APPLICATION NO.	FILING DATE	FIRST NAMED INVENTOR	ATTORNEY DOCKET NO.	CONFIRMATION NO.
10/605,883	11/04/2003	David J. Houston	28647.00003	2882
	7590 07/17/200' VRIGHT PLLC	EXAMINER		
1901 L. STREE		CHAMBERS, MICHAEL S		
SUITE 800 WASHINGTO	N, DC 20036		ART UNIT	PAPER NUMBER
	•		3711	
		• •		
			MAIL DATE	DELIVERY MODE
			07/17/2007	PAPER

Appl	lication No.	Applicant(s)			
	Office Action Commence	10/6	605,883	HOUSTON ET A	L.		
٠.	Office Action Summary	Exar	niner	Art Unit			
			Chambers	3711			
Period fo	The MAILING DATE of this communic r Reply	cation appears o	on the cover sheet	with the correspondence a	ddress		
WHIC - Exten after: - If NO - Failur Any re	CRIENCE STATUTORY PERIOD FOR HEVER IS LONGER, FROM THE MANISIONS of time may be available under the provisions of SIX (6) MONTHS from the mailing date of this community period for reply is specified above, the maximum state to reply within the set or extended period for reply weeply received by the Office later than three months afted patent term adjustment. See 37 CFR 1.704(b).	AILING DATE On 137 CFR 1.136(a). In unication. State yellow yello	OF THIS COMMUN n no event, however, may and will expire SIX (6) M he application to beco

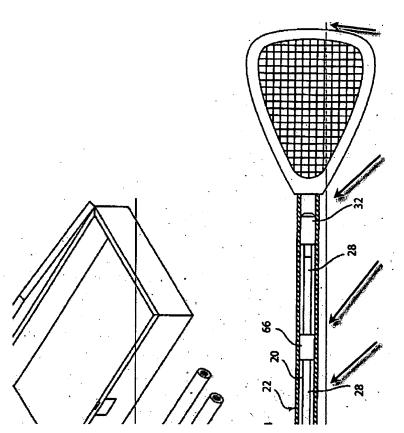
The drawings that were received on 10/5/06 are acceptable for examination purposes only. The fax drawings have an additional line inserted in 6 of the 10 drawings. An example is shown below. The current drawings were filed 10/05/06, the drawings used for the PGPUB publication were filed 11/04/03. As noted in the prior office action, the applicant's fax machine places a line through all the drawings, as noted below and in the prior office action. Since the last drawings filed in the application are used for publication if the application is allowed, the current drawings are unacceptable.
